**Draft Director's Report
for the 2018 Integrated Resource Plan**

Dr. Bradley Borum
Director of Research, Policy and Planning
on behalf of the Indiana Utility Regulatory Commission

IRP submitted by Northern Indiana Public Service Company, LLC

Draft Director's Report Applicable to Northern Indiana Public Service Company's 2018 Integrated Resource Plan and Planning Process

Table 3-5: Industrial Energy Sales (Page 23)

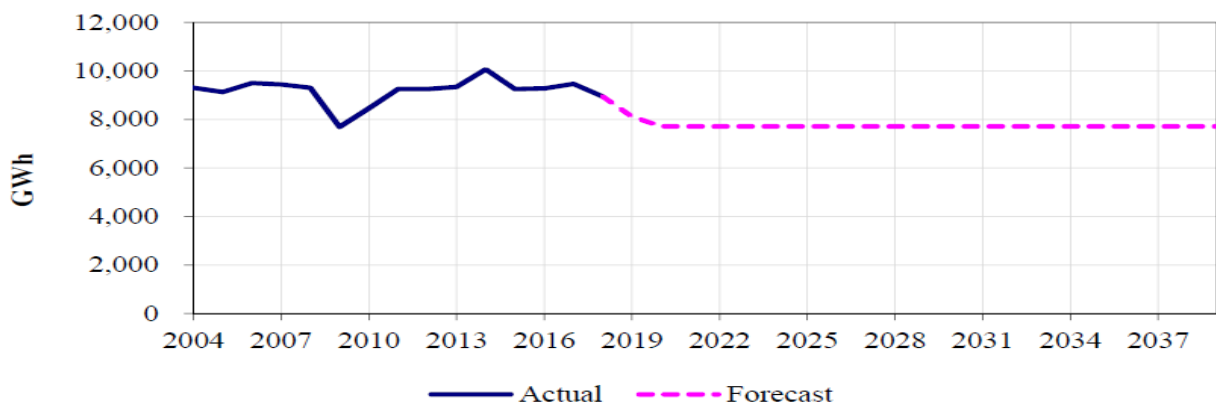
NIPSCO's forecast for the remaining industrial customers is based primarily on historical data from the past six years with greater weight given to the most recent year. (Page 23)
